TECHNICAL BULLETIN: TB15-03

Pro Series/Reese Select Series 5th Wheel: Service and Inspection Recommendation

Pro Series / Reese Select 5th Wheel

- 16K Pro Series
- 20K Pro Series
- 16K Reese Select

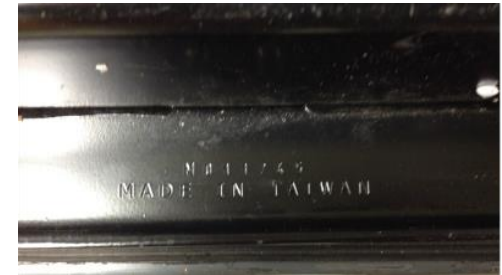
A. Units with MFG build date 2012 thru 2014 are suspect if they have:

- MFG Date Codes between M011201 – M011431
(Example 1201 is first week of Jan 2012)

AND

- The C-clip design shown here

B. Units with MFG Date codes M011200 – M011431 are **OK** if they have either:

- A green dot or blue paint mark on the head assembly

OR

- The updated C-clip design

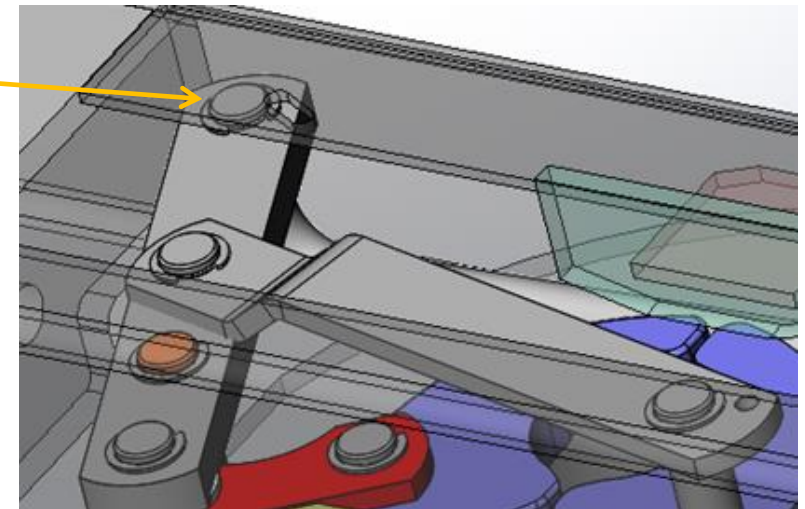
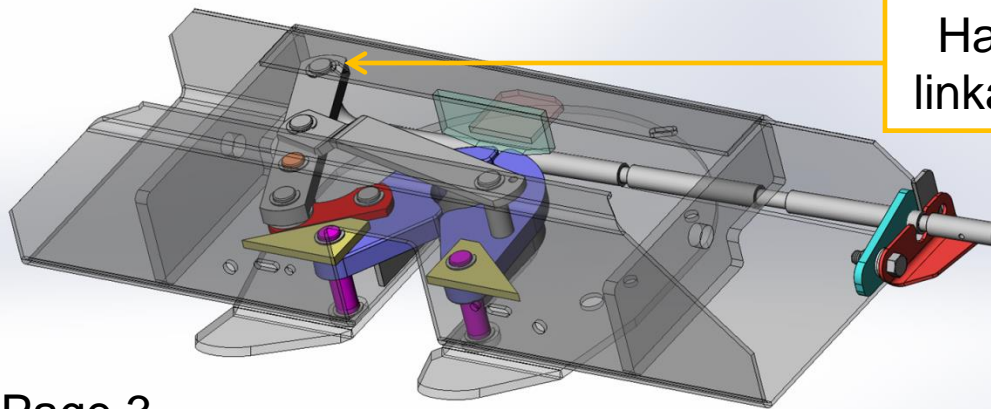
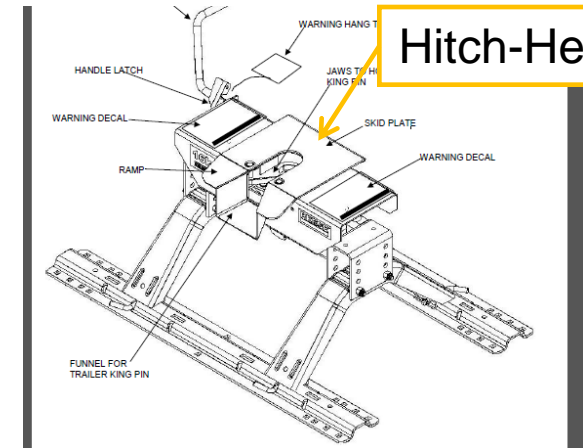
- A. Remove the 5th Wheel Hitch – Head
- B. Lay on workbench upside down
- C. Inspect C-Clip to see if it is installed correctly at the handle to linkage joint (see page 4). *If installed correctly: the C-Clip will be at the prescribed location and will rotate by hand or screw driver force.*
- D. If the C-Clip is missing or not installed correctly, contact Reese for service kit 58526. Disconnect handle as identified below and install replacement C-Clip. **Warning: do not use or sell prior to replacing C-Clip!**
- E. Service Kit: C-Clips will have colored paint dot on clips.
